1200-1340 OLD BAYSHORE HIGHWAY PROJECT

Response to Comments Document

Prepared for
City of Burlingame

Revised Figure 3-4
Proposed Ground Level Site Plan

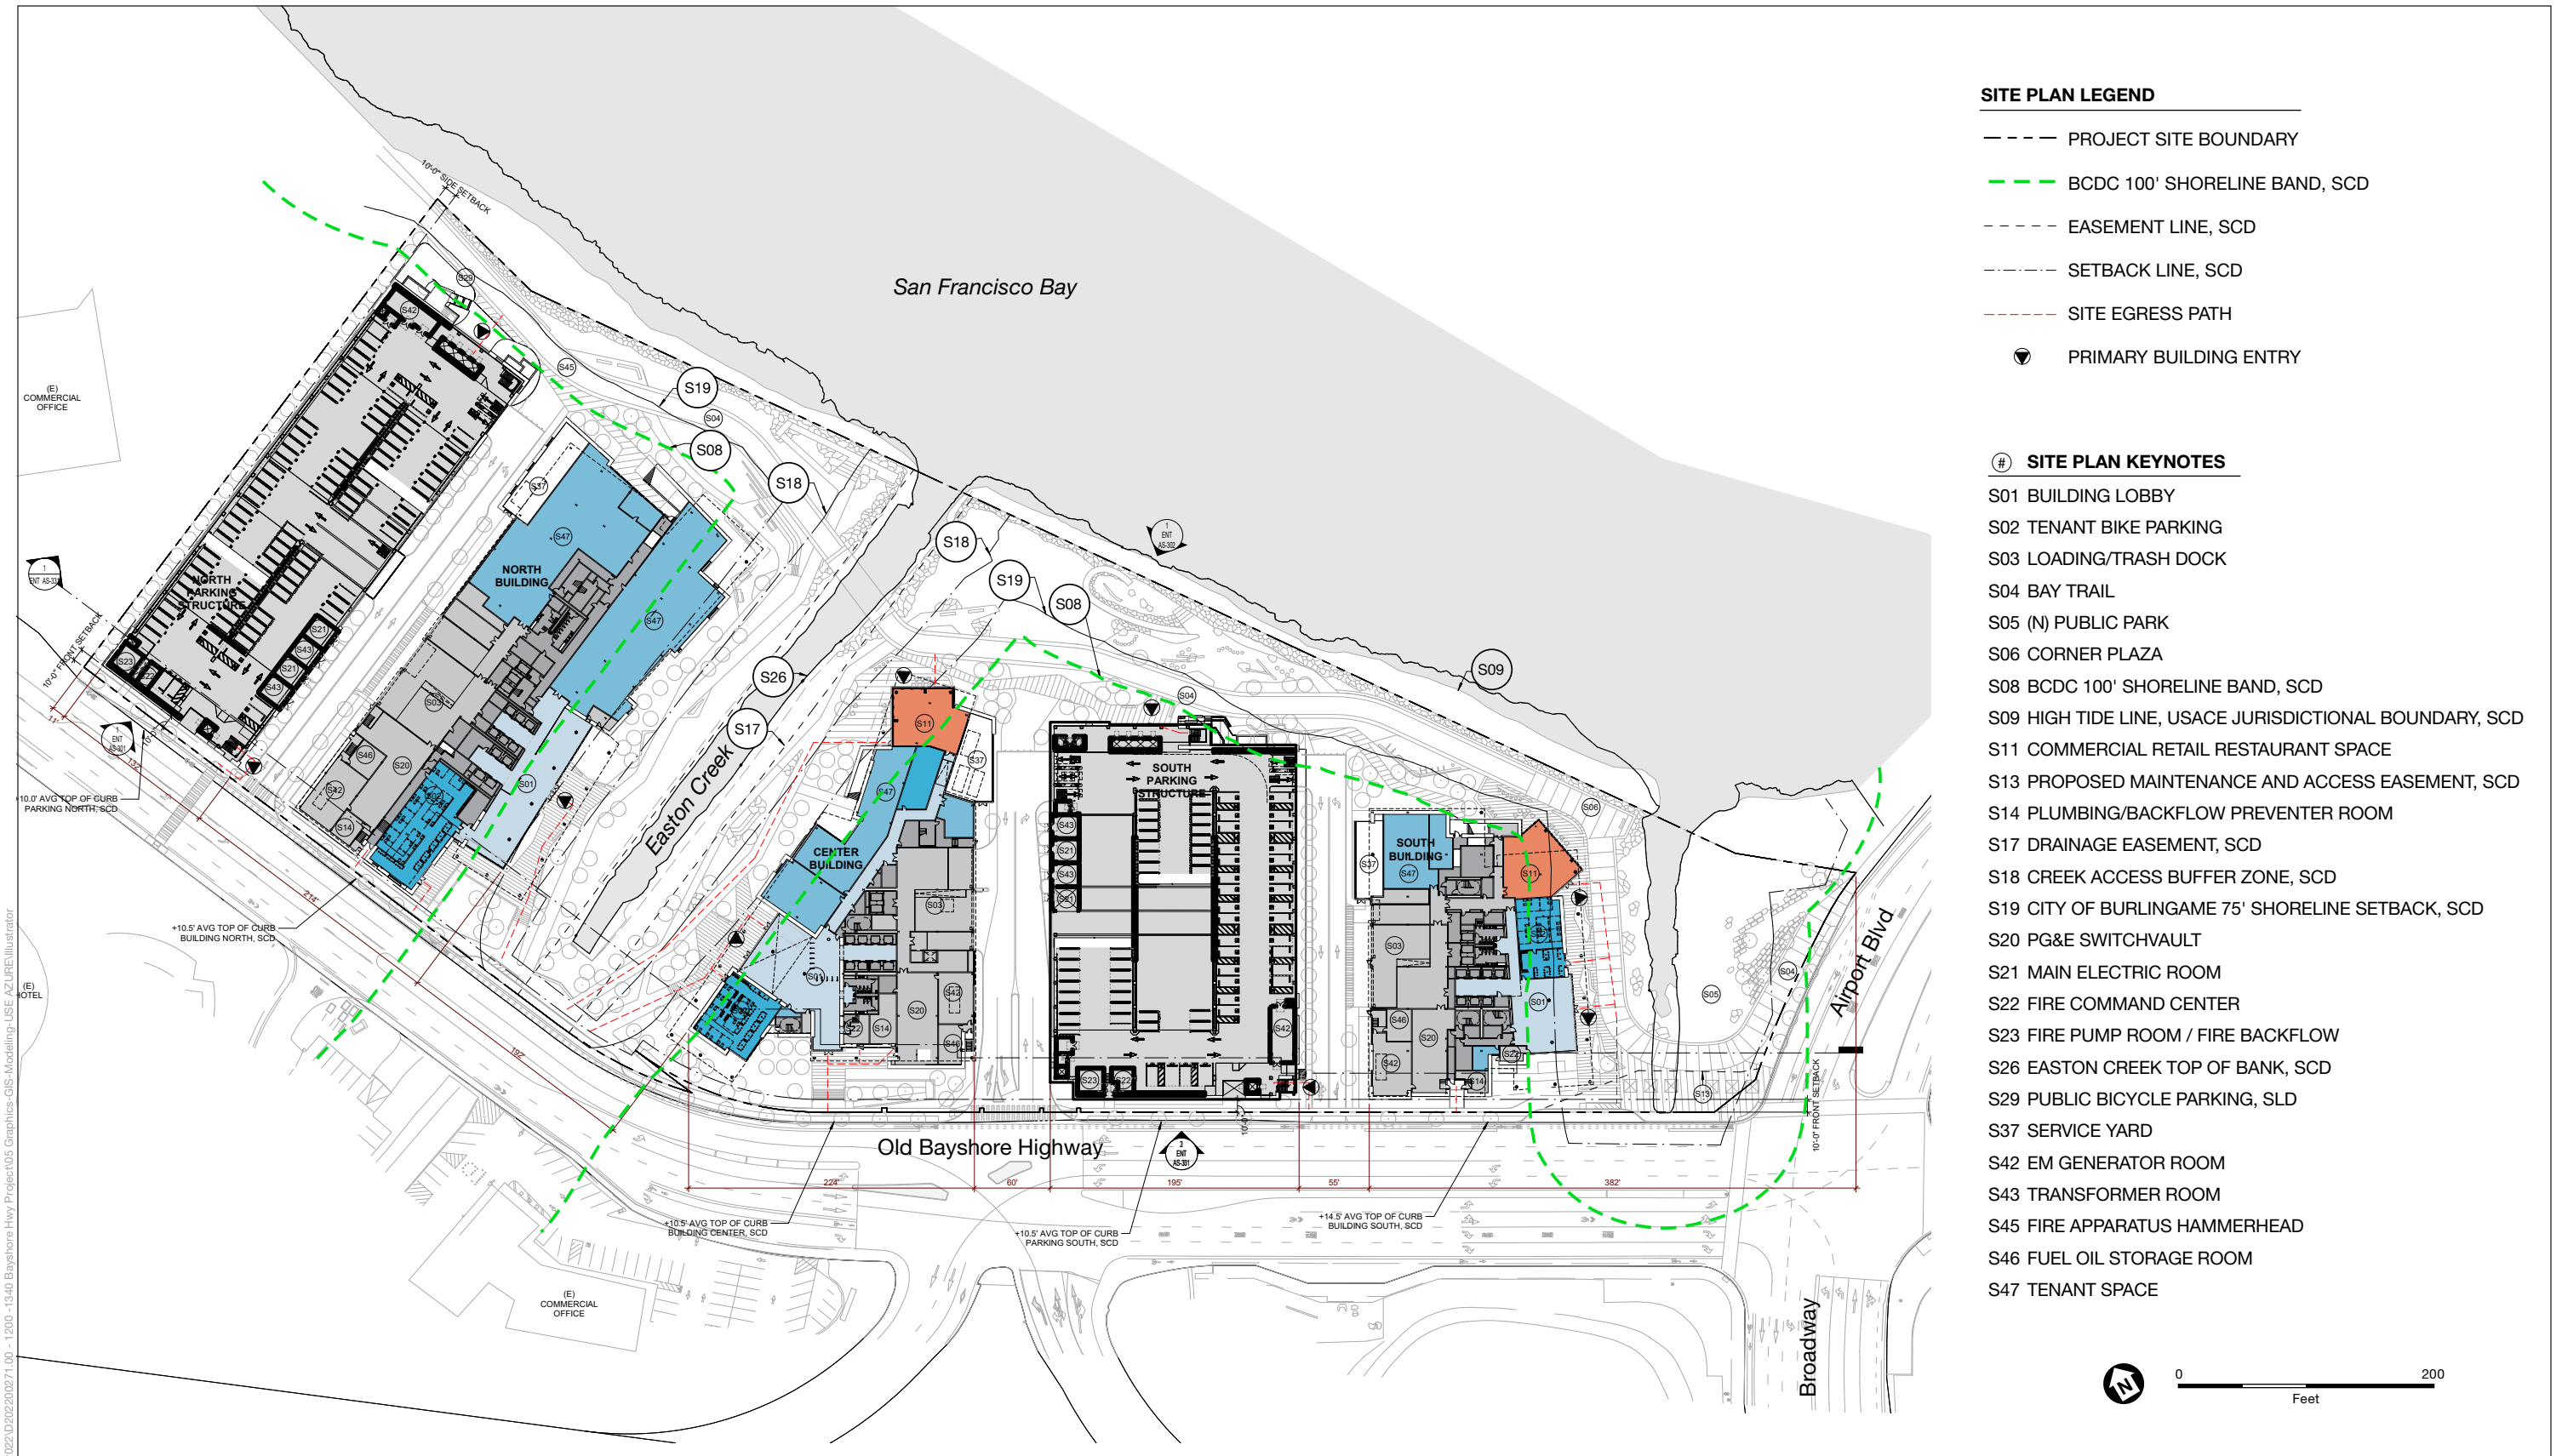
A-BCDC-3 The commenter indicates the BCDC jurisdictions depicted in Draft EIR Figures 3-4 through 3-7 appear to be from an older understanding of its jurisdictional limits. The commenter indicates the notes in Figure 3-4 are not legible in the DEIR PDF, and should be made larger and more clear. The commenter requests at least one figure in the EIR with current information and ensure that it is clearly labeled.

Figures 3-4 through 3-7 have been revised to reflect the current BCDC 100-foot shoreline band; labels and titles for jurisdictional limits on the figures have been made clearer; and Figure 3-4 is enlarged from an 8½ x 11-inch to a 11 x 17-inch dimension. Please refer to Chapter 4, *Revisions to the Draft EIR*, of this Response to Comments document for the revised figures.

Figures 3-4 through 3-7 presented on the following pages have been revised in response to Comment A-BCDC-3.
